ADDENDUM #02
TO
INVITATION TO BID #01

March 14, 2018

WESTERN CONNECTICUT STATE UNIVERSITY
RENOVATIONS TO
HIGGINS HALL & HIGGINS ANNEX

STATE PROJECT NO: BI-RD-290-CMR

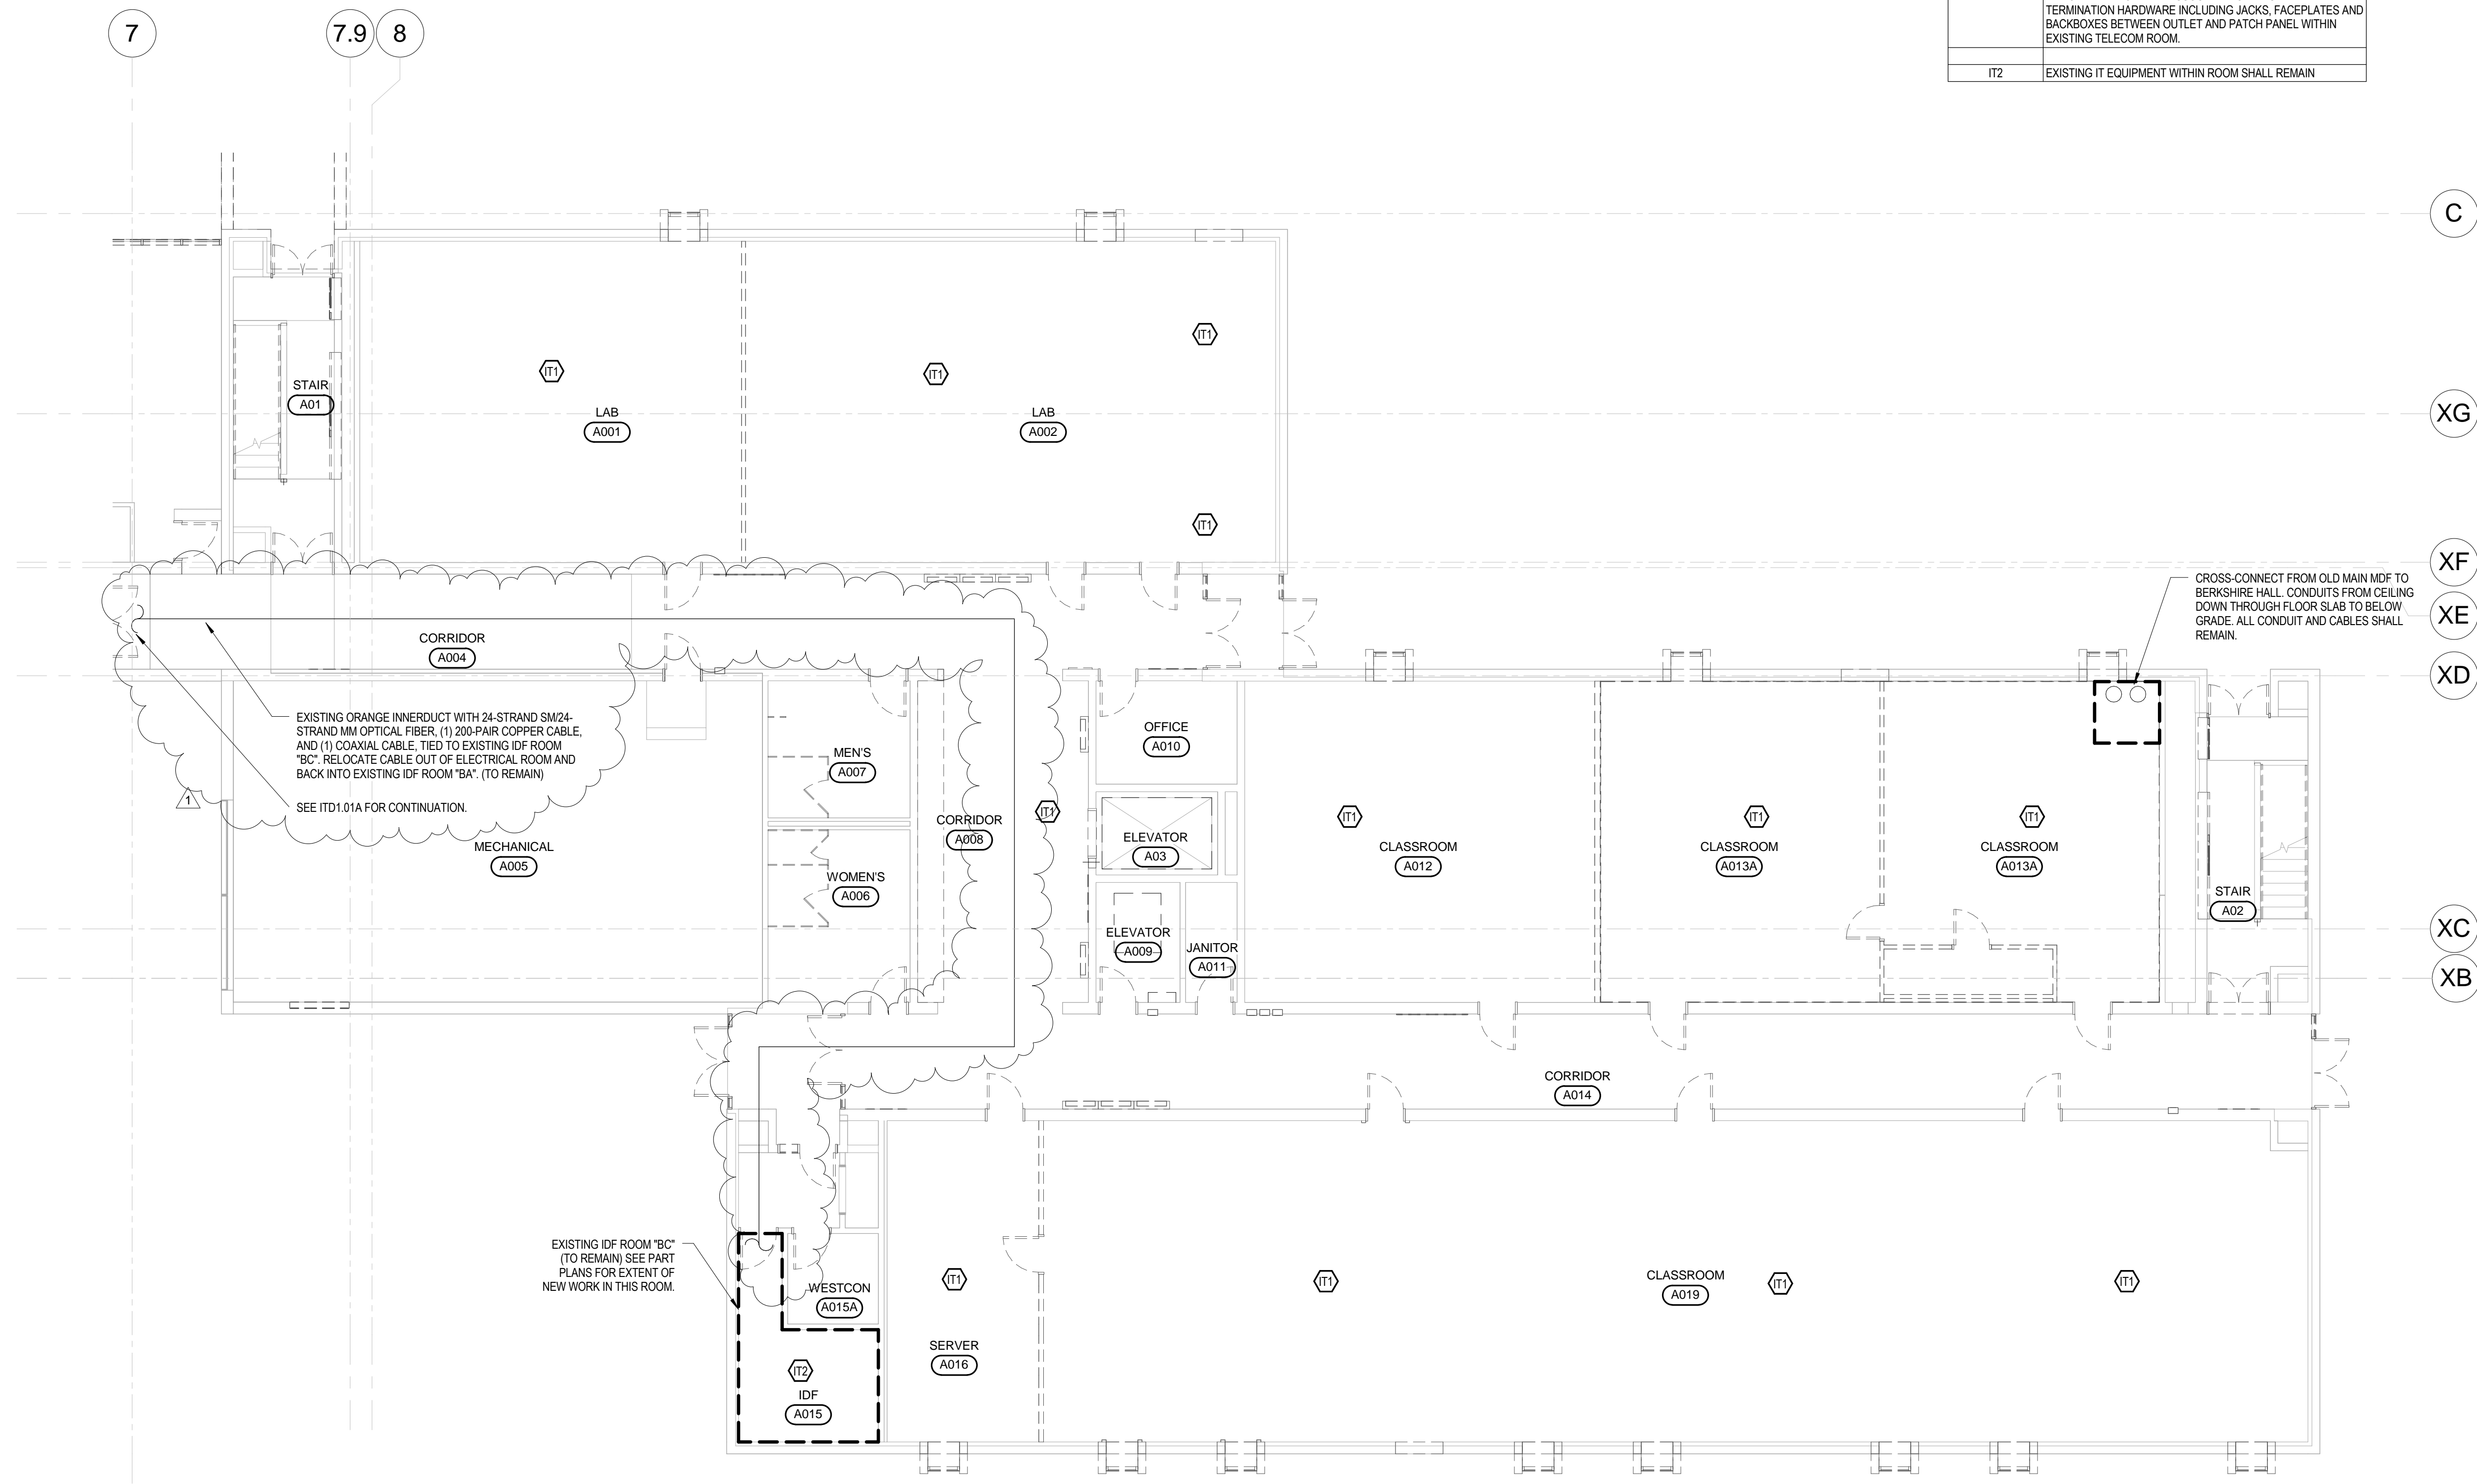
- 17. ITD1.01A:
 - Replace drawing with revised ITD1.01A.
- 18. ITD1.01B:
 - Replace drawing with revised ITD1.01B.
- 19. IT1.01:
 - Replace drawing with revised IT1.01.
